# SAN FRANCISCO PLANNING DEPARTMENT

## Discretionary Review Full Analysis

*Date:* September 22, 2016  
*Case No.:* 2015-007313DRP-05VAR  
*Project Address:* 870-872 UNION STREET  
*Permit Applications:* 2015.11.13.2622 &  
2015.11.13.2623  
*Zoning:* RM-1 (Residential-Mixed, Low Density)  
40-X Height and Bulk District  
*Block/Lot:* 0100/020, 085-087  
*Project Sponsor:* Brian Milford  
Martinkovic Milford Architects  
101 Montgomery Street, Suite 650  
San Francisco, CA 94104  
*Staff Contact:* Nicholas Foster – (415) 575-9167  
[nicholas.foster@sfgov.org](mailto:nicholas.foster@sfgov.org)  
*Recommendation:* **Do not take DR and approve the project as proposed.**

**A205**

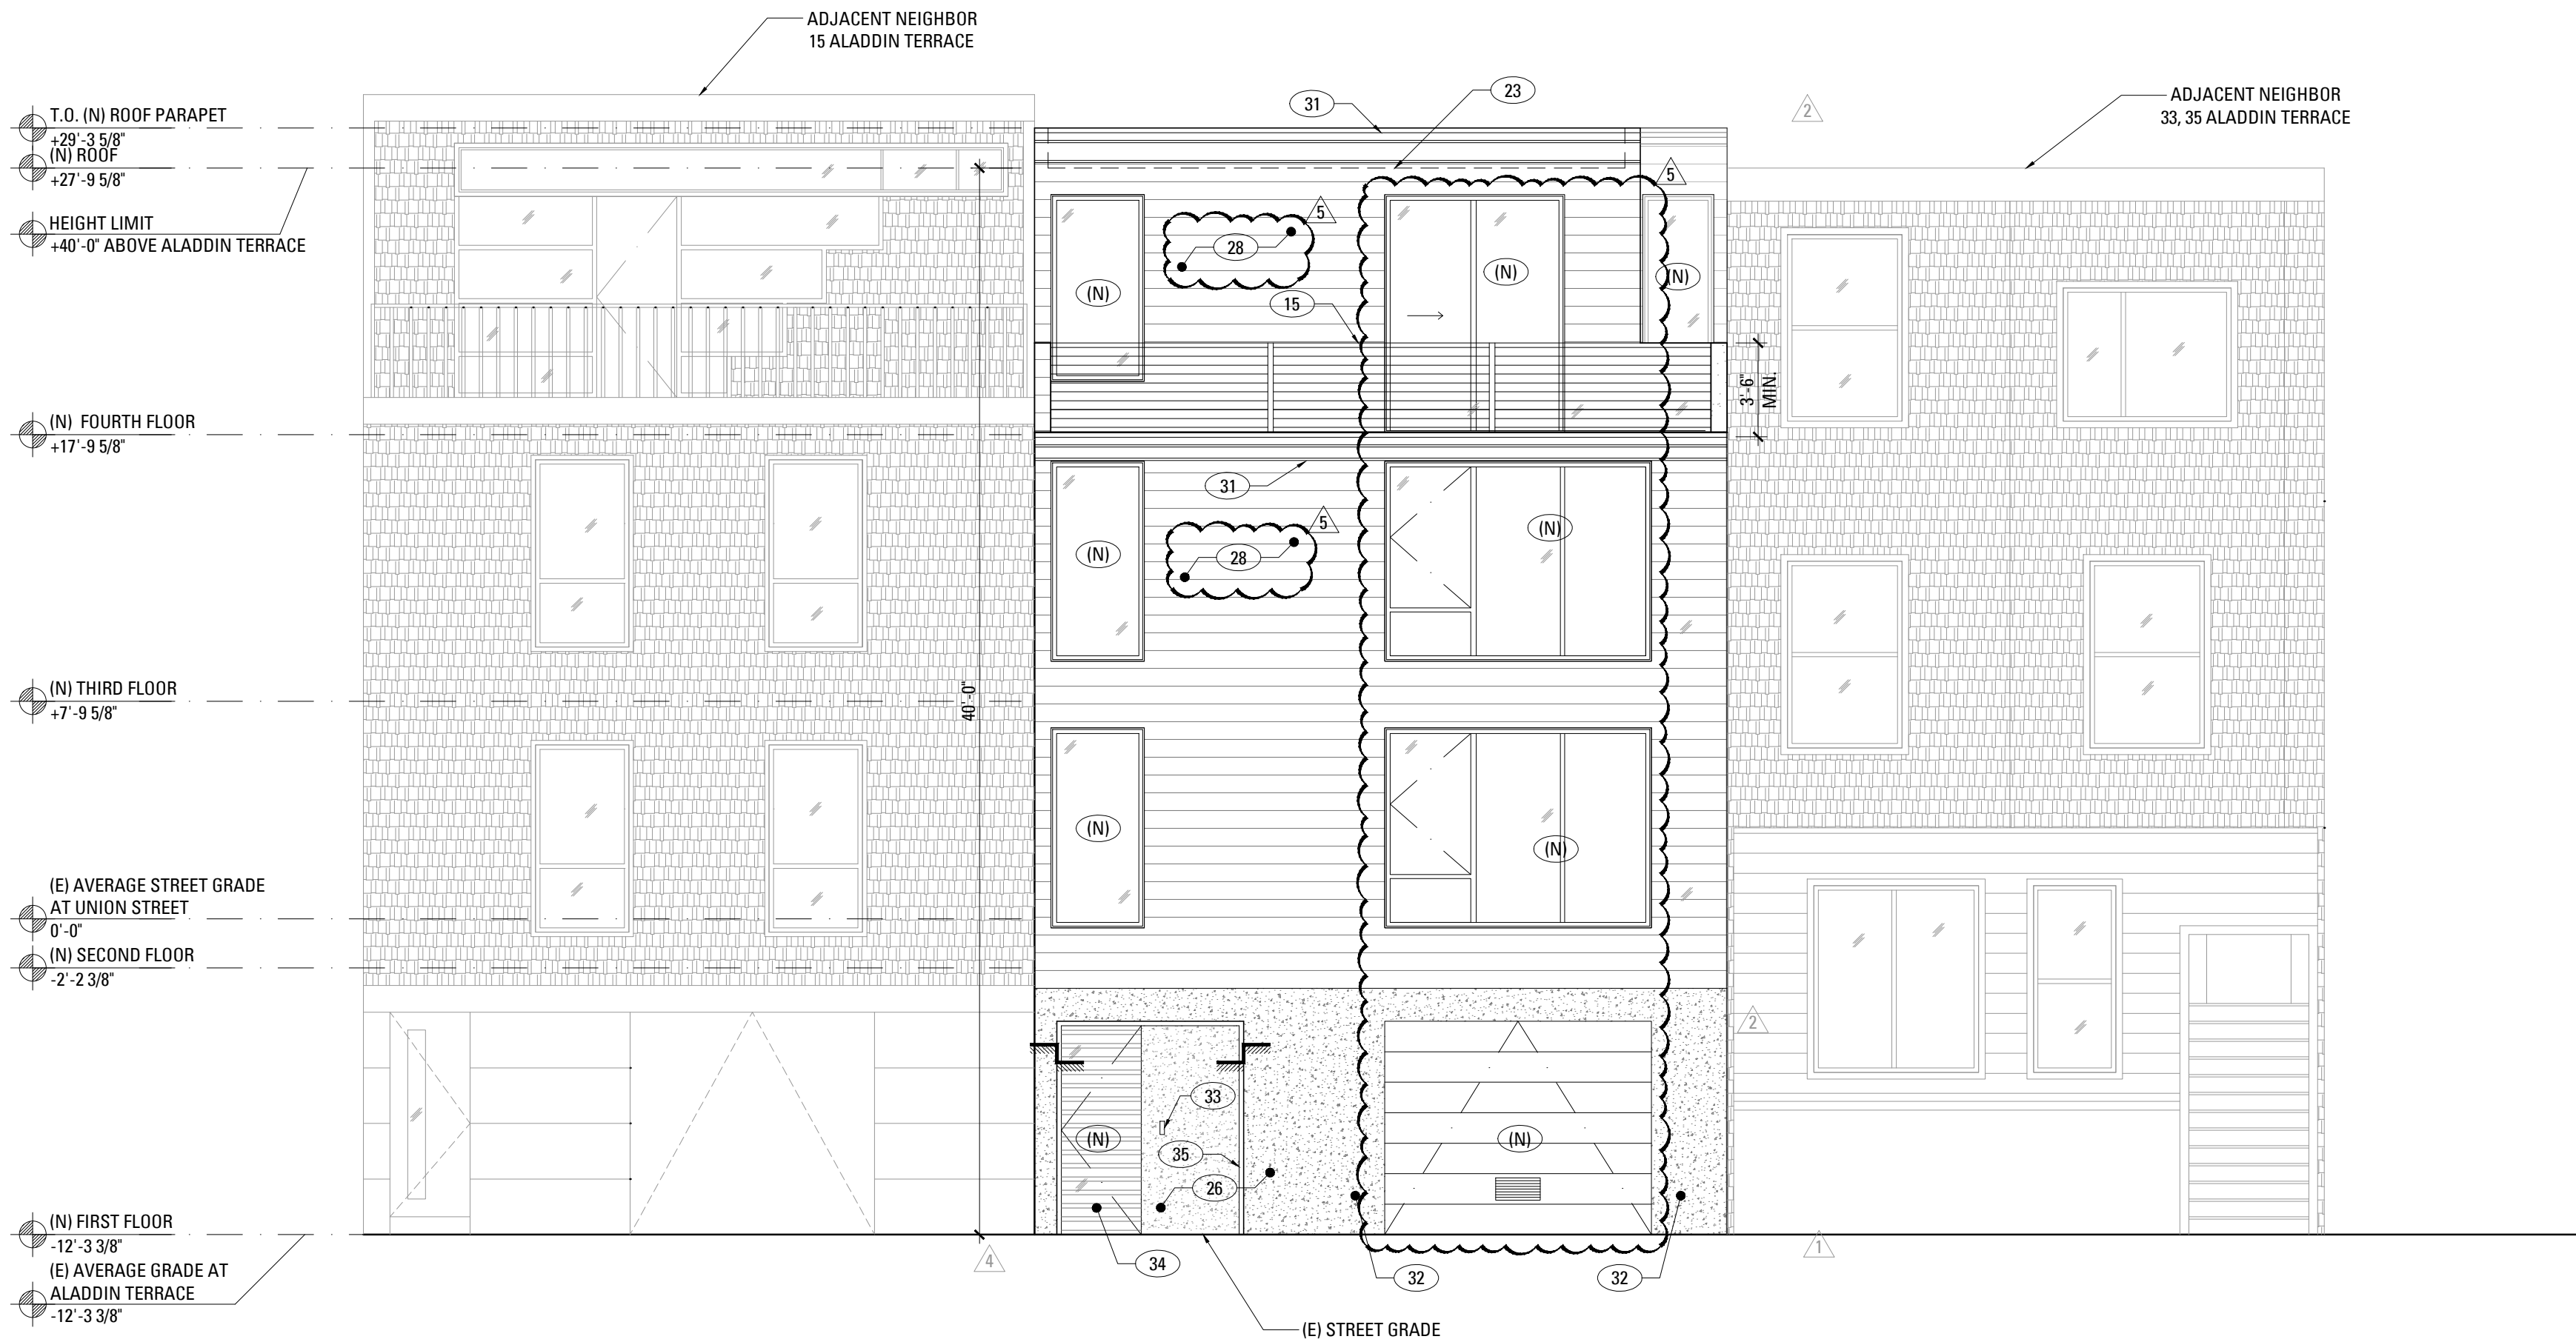
4.	A206	Revise the façade design to reflect a solid to glazing ratio more in keeping with the vertical proportions of the neighboring buildings.	See sheet A206 for the revised proposal of the front façade design.	MMA

5.	A206	Provide Exterior materials compatible with neighboring buildings.	See sheets A205 and A206 for the proposed exterior materials. The primary exterior façade materials of the immediate neighboring buildings are painted wood siding, painted plaster, wood shingles, and concrete. See the attached photos of the existing neighboring buildings.	MMA

7.	A206	Provide more information on the green wall system. Specifically RDT questions how architecturally integral, permanent, and sustainable it will be.	See sheet A206 for the revised front façade. The green wall system has been removed from the scope of work.	MMA
